Approved For Construction
City of Deer Park
Engineering Dept.

WILDWOOD DRIVE
(50' ROW)

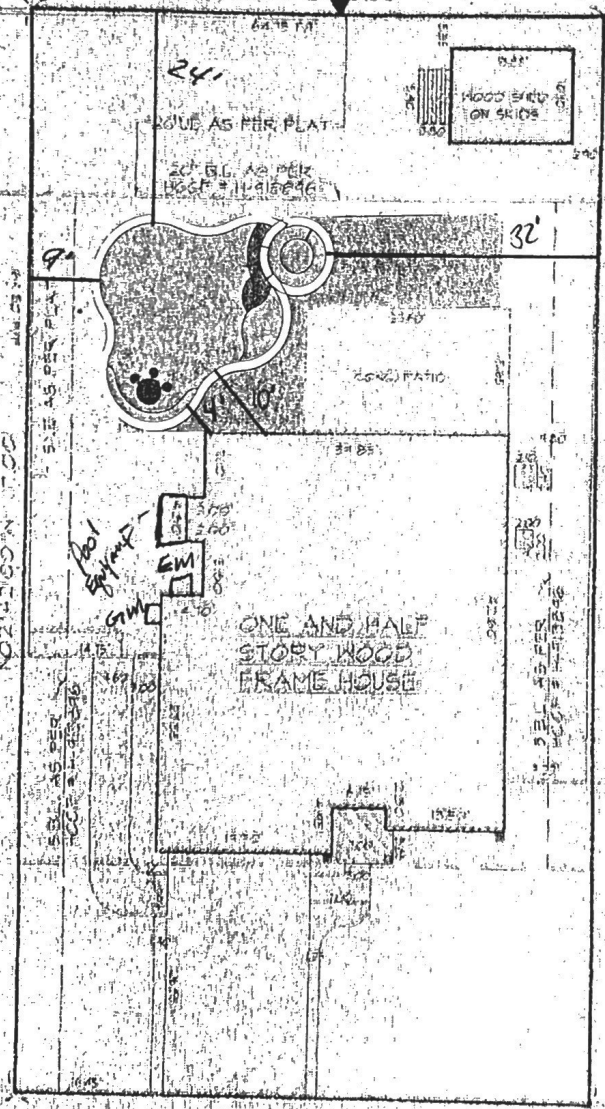
⊗ Access From Rear Yard (customer will get sign off showing it's OK to do so)

No Access thru Private Easement without written Approval letter to the Contractor from the Easement Owner.
